INDIANA DEPARTMENT OF TRANSPORTATION

APPROVED MINUTES

June 18, 2009 Standards Committee Meeting

SURVEY LINE MONUMENTS

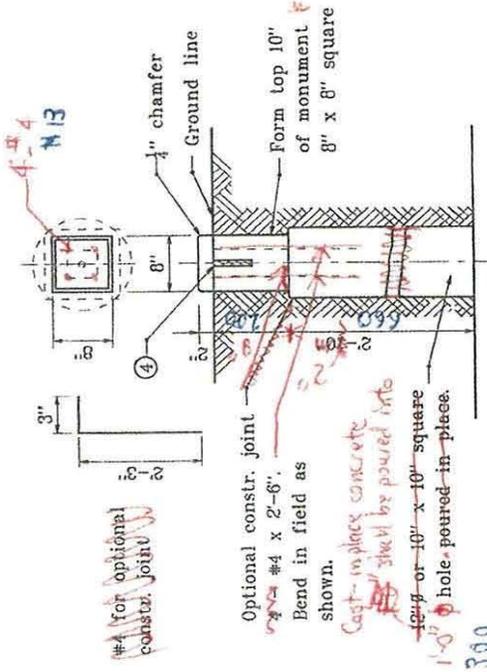
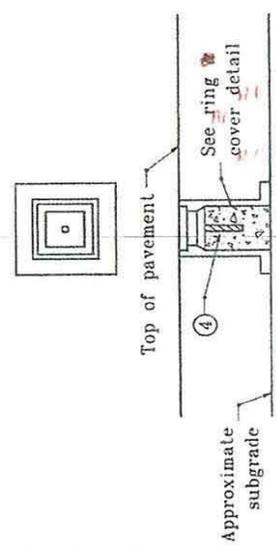
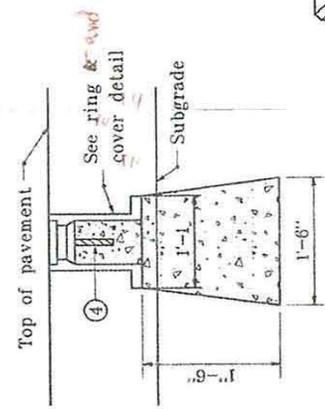
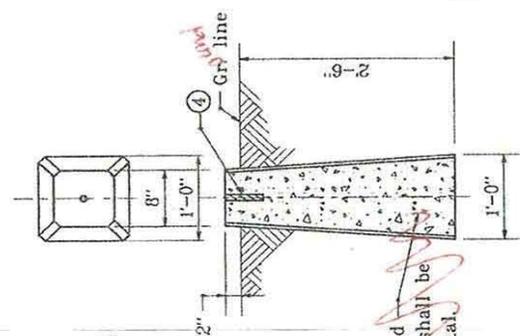
The Standard Drawings regarding monuments require editorial corrections for consistency and clarity.

Current 615-SLMN-01 becomes new 615-SMON-01

INDIANA DEPARTMENT OF TRANSPORTATION
 SURVEY-MONUMENT SIGN
 BENCH-MARK POST

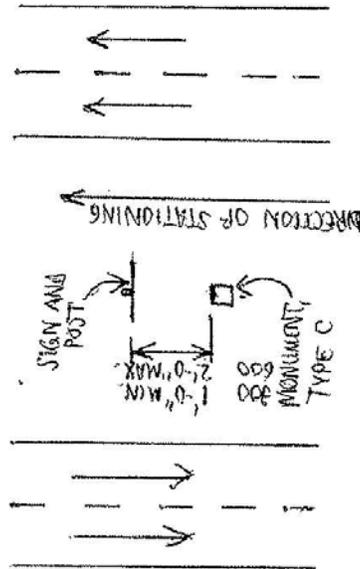
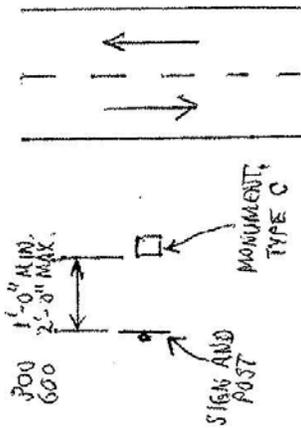
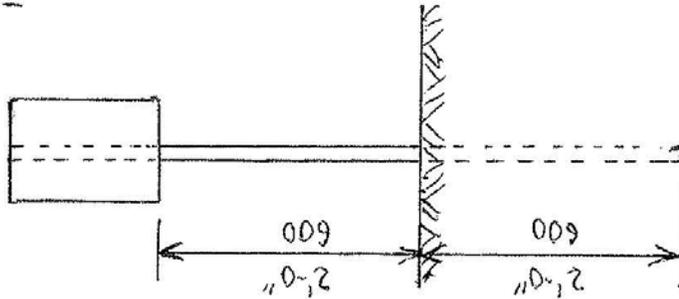
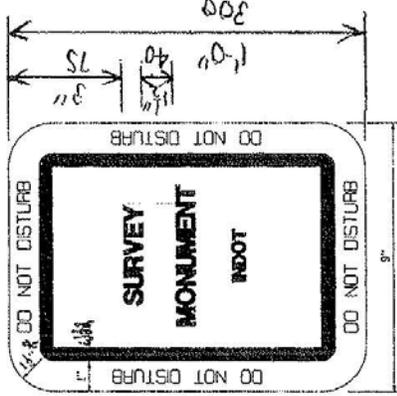
The standard documents are silent regarding placement, method of measurement, and basis of payment for a "Survey Monument INDOT" sign, now detailed in the Standard Drawings.

The survey-monument-sign placement details become new 615-SMON-02

SECTION-CORNER MONUMENTS

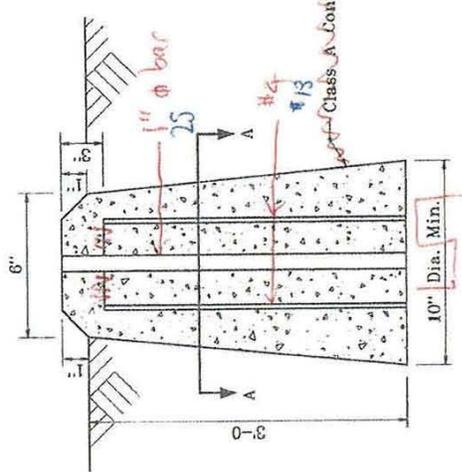
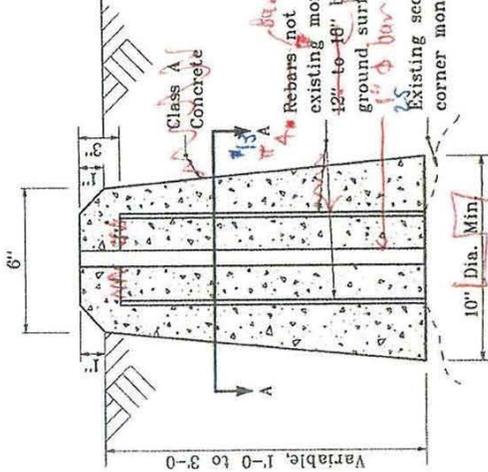
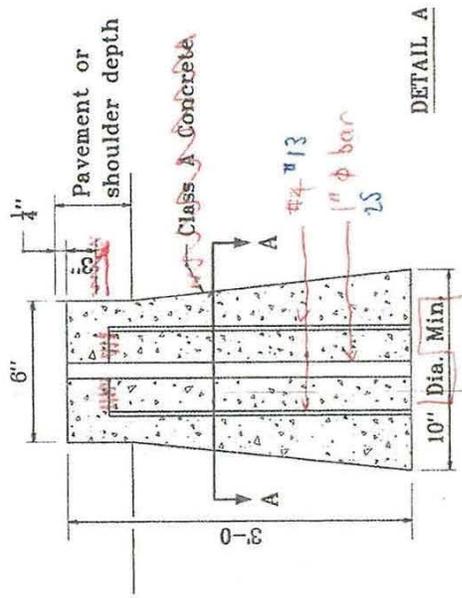
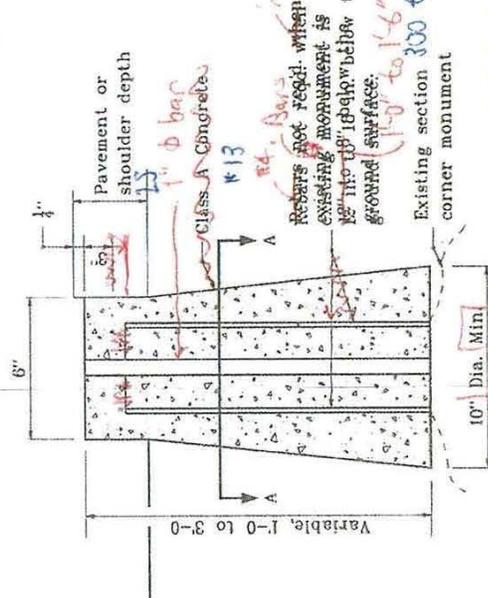
Current 615-SCMN-01 becomes new 615-SMON-03

1. If the existing section corner monument is ~~to~~ 1 ft below ~~the~~ surface, it shall be removed and replaced as shown in Detail A.
2. If the existing section corner monument is ~~over~~ 1 to 3 ft below the surface, the county surveyor ~~shall~~ determine whether it shall remain in place or be replaced. If the monument is to be replaced, the installation shall be as shown in Detail A. If the ~~existing~~ monument is to remain in place, it shall be extended as shown in Detail ~~A~~ **B**.

ADJACENT BOX BEAM DETAILS
Figure-63-8C

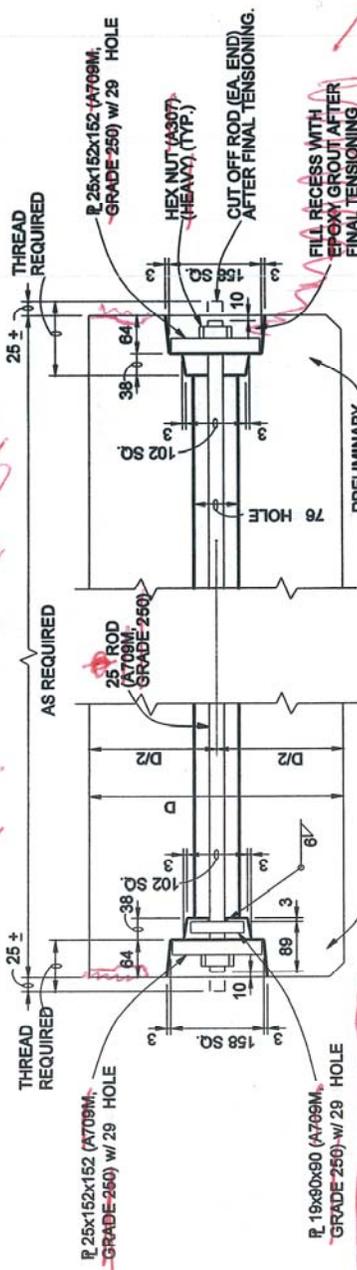
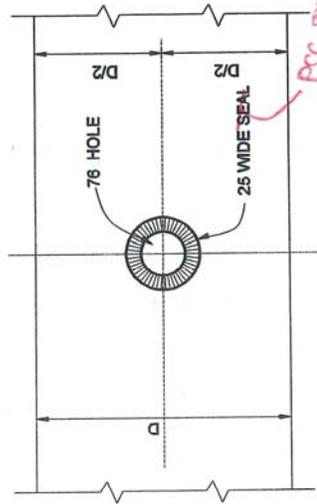
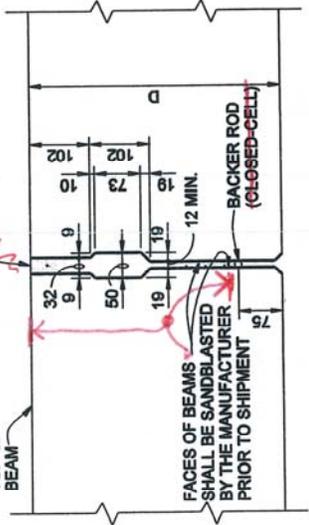
PROBLEM(S) ENCOUNTERED: Design Manual Figure 63-8C for Adjacent Box Beam Details is considered to be a standard detail.

PROPOSED SOLUTION: Make this design manual figure into a standard drawing and take the specification-type notes off of this drawing and insert them into the SS.

TRANSVERSE TENSIONING RODS: AFTER THE BEAMS ARE IN PLACE, PERFORM A PRELIMINARY TIGHTENING TO THE TRANSVERSE TENSIONING RODS. PERFORM FINAL TENSIONING THAT YIELDS 138 MPa AS DEVELOPED BY A TORQUE OF 271 N·m. PROVIDE TRANSVERSE TENSIONING RODS AND PLATES CONFORMING TO ASTM A709M GRADE 250 WITH HEAVY HEX NUTS CONFORMING TO ASTM A307.

ALL OVERSTROKE COPY TO STO SPEC - MATLS

DUPLICATED IN NOTE ABOVE

TO STO SPEC - CONST.

Tensioning rods and steel plates used with adjacent prestressed-concrete box beams shall be in accordance with ASTM A 706, Grade 36 (A 706M, Grade 250). Nuts used with such tensioning rods shall be heavy hex in accordance with ASTM A 563 (A 563M). Grout used with such beams shall be non-shrink in accordance with ASTM C 1107.

After adjacent prestressed-concrete box beams are in place, the transverse tensioning rods shall be preliminarily tightened ~~where~~ as shown on the plans. The rods shall be final tensioned ~~where~~ as shown on the plans. The final tensioning shall yield 20,000 psi (138 MPa) as developed by means of a torque of 19 lb-ft (271 N-m). The tensioning-rod recesses and longitudinal joints between beams shall be filled with grout.
